# SERVICE BULLETIN

NON-MODIFICATION SERVICE BULLETIN — NO. 3 BEARING — REDUCED MASTER  
MAGNETIC CHIP DETECTOR INSPECTION INTERVAL FOR SUSPECT POPULATION (LOT A)

V2522-A5, V2524-A5, V2527-A5, V2527E-A5, V2527M-A5, V2530-A5, V2533-A5

**V2500-ENG-72-0671**

FLOW CHART A  
FIGURE 1

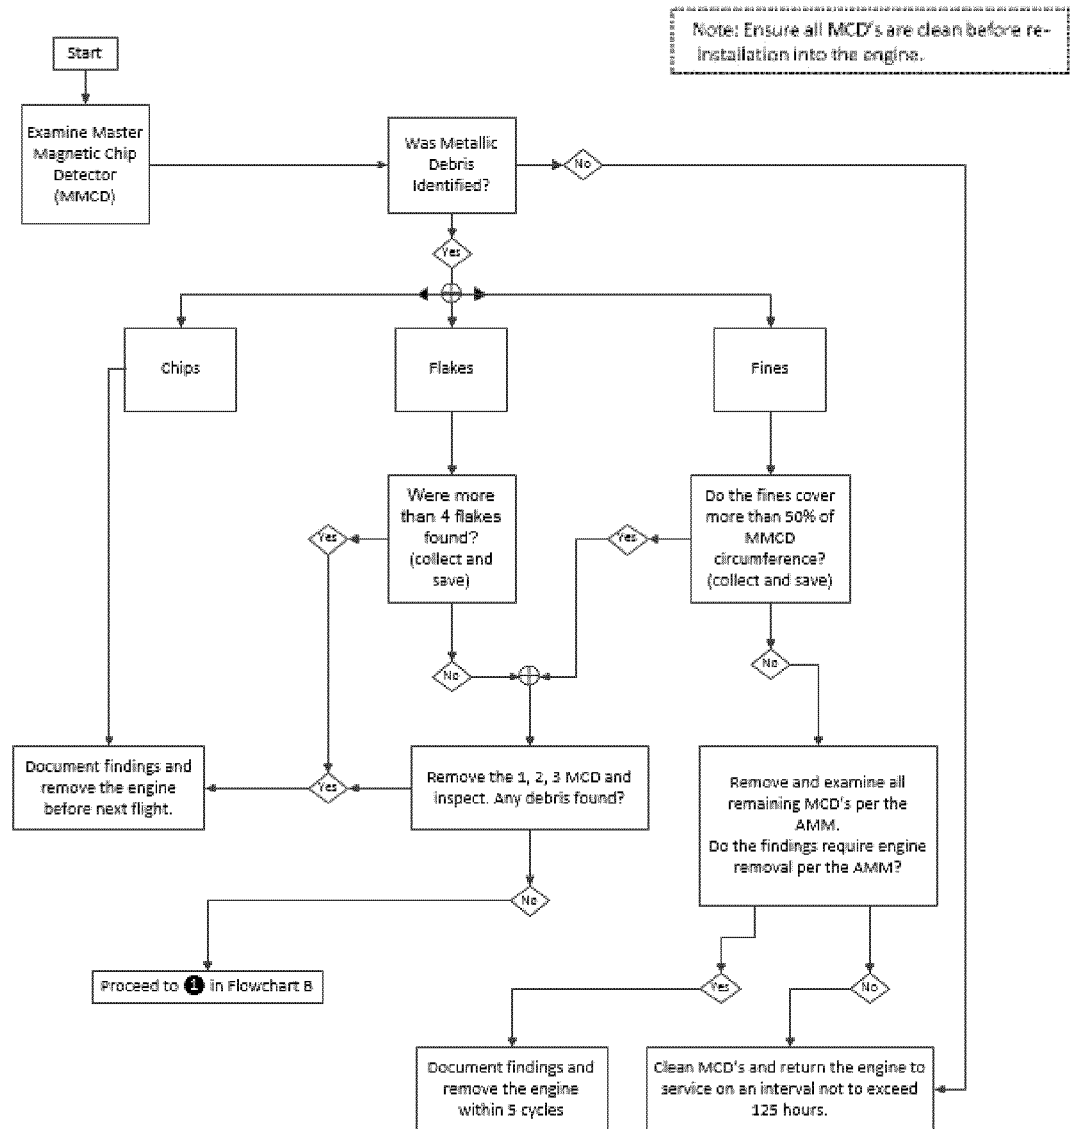
1. Remove and examine the Master MCD (Position 1) for metallic debris as specified in Reference 2, Aircraft Maintenance Manual (AMM), TASK 79-00-00-200-014-A. See Figure 1.

2. Was metallic debris found?
  - A. If metallic debris was not found, return engine to service on an inspection interval not to exceed 125 hours.
  - B. If findings were detected during the MMCD inspection, determine what type of metallic debris was found using the AMM definitions and figures as specified in Reference 2, AMM, TASK 79-00-00-200-011-A.

- (1) Was the metallic debris identified as chips?
      - (a) If yes, proceed to Step 3.
    - (2) Was the metallic debris identified as flakes?
      - (a) If yes, proceed to Step 4.

- (3) Was the metallic debris identified as fines?
      - (a) If yes, proceed to Step 5.
3. Type of debris from MMCD inspection determined to be chips:

- A. No chips are allowed. If chips are identified, the findings should be documented and the engine should be removed from service before the next flight.

4. Type of debris from MMCD inspection determined to be flakes:
  - A. Was a quantity of flakes found to be more than four?
    - (1) If yes, document the findings and remove the engine before the next flight.

- (2) If no, collect the flakes and save for later analysis. Proceed to the following step.
  - B. Quantity of flakes found to be four or less:
    - (1) Remove the 1, 2, 3 MCD (Position 2) and inspect for debris. Proceed to the following step.

- (a) Was any debris found during examination of the 1, 2, 3 MCD?
        - 1 If yes, document the findings and remove the engine before the next flight.

- 2 If no, proceed to next step.
- (2) Remove all remaining MCD's and inspect to the AMM as specified in Reference 2, AMM, TASK 79-00-00-200-011-A.
- (a) Were there any findings on the remaining MCD's that required engine removal per the AMM?

5. Type of debris from MMCD inspection determined to be fines:
  - A. Do the fines found during the MMCD inspection cover more than 50% of MMCD circumference? (Use Figure 79(IAE)-00-00-991-15200-A, Sheet 1. Refer to Reference 2, AMM, TASK 79-00-00-200-011-A).

- (1) If yes, proceed to Step 5.B.
    - (2) If no, collect the debris and save for later analysis, then remove and examine all MCD's per the AMM and proceed to the following step as specified in Reference 2, AMM, TASK 79-00-00-200-011-A.

- (a) Does inspection of the remaining MCD's require engine removal per the AMM?
        - 1 If yes, document the findings and remove the engine within five flight cycles.

- 2 If no, clean MCD's and return the engine to service on an inspection interval not to exceed 125 hours.
  - B. The fines on the MMCD cover more than 50% of MMCD circumference:

- (1) Collect the debris and save for later analysis. Then remove the 1, 2, 3 MCD (Position 2) and inspect for debris.
      - (a) Was any debris found during inspection of the 1, 2, 3 MCD?

- 1 If yes, document the findings and remove the engine before the next flight.
        - 2 If no, proceed to the following step.
6. Remove and examine all remaining MCD's and inspect to the AMM as specified in Reference 2, AMM, TASK 79-00-00-200-011-A.

- A. Were there any findings on the remaining MCD's that required engine removal per the AMM?
    - (1) If yes, document the findings and remove the engine before the next flight.

- (2) If no, proceed to Step 4.C.

FLOW CHART B  
FIGURE 2

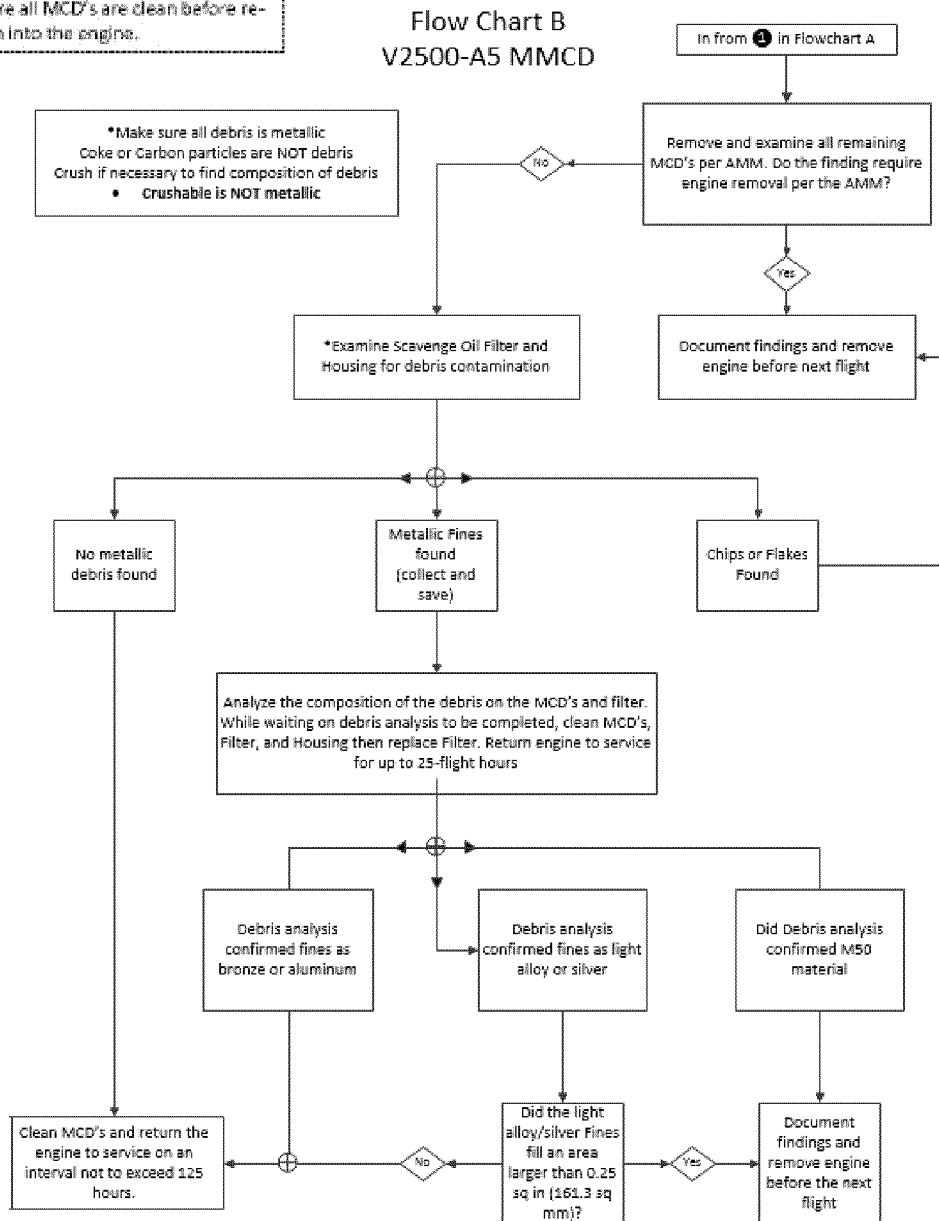
- 1 If yes, document the findings and remove the engine before the next flight.
- 2 If no, proceed to Step 4.C.
- C. Examine the scavenge oil filter and housing for debris contamination as specified in Reference 2, AMM, Chapter/Section 79-00-00. See Figure 2.

- (1) Was any debris found during examination of the Scavenge oil filter and housing?
- (a) If yes, determine what type of debris was found using AMM definitions and figures as specified in Reference 2, AMM, TASK 79-00-00-200-011-A. Proceed to Step 4.C.(2) for chips and/or flake findings and Step 4.C.(3) for metallic fines findings.

- (b) If no, return the engine to service on an inspection interval not to exceed 125 hours.
- (2) Chips or flakes found during examination of the scavenge oil filter and housing:

- (a) Document the findings and remove the engine before the next flight.
- (3) Metallic fines found during examination of the scavenge oil filter and housing:

- (a) Collect the debris, measure the amount of findings, then analyze the composition of the debris on the plugs and filters. While waiting on debris analysis to be completed, clean MCDs, filter and filter housing, re-install, then return the engine to service for up to 25 flight hours. Proceed to the following step in addition to putting the engine on a 25 flight hour interval.

- (4) Debris analysis completed from the previous step:
- (a) Debris analysis confirmed M50 material:
- 1 Document the findings and remove the engine before the next flight.

- (b) Debris analysis confirmed fines as bronze or aluminum:
- 1 Return the engine to service on an inspection interval not to exceed 125 hours.
- (c) Debris analysis confirmed fines as light alloy or silver:

- 1 Measure the amount of light alloy/silver fines and proceed to the following step.
- a Do the light alloy/silver fines fill an area larger than 0.25 sq in (161.3 sq mm).

- (1) If yes, document the findings and remove the engine before the next flight.
- (2) If no, return the engine to service on an inspection interval not more than 125 hours.

Note: Ensure all MCD's are clean before re-installation into the engine.
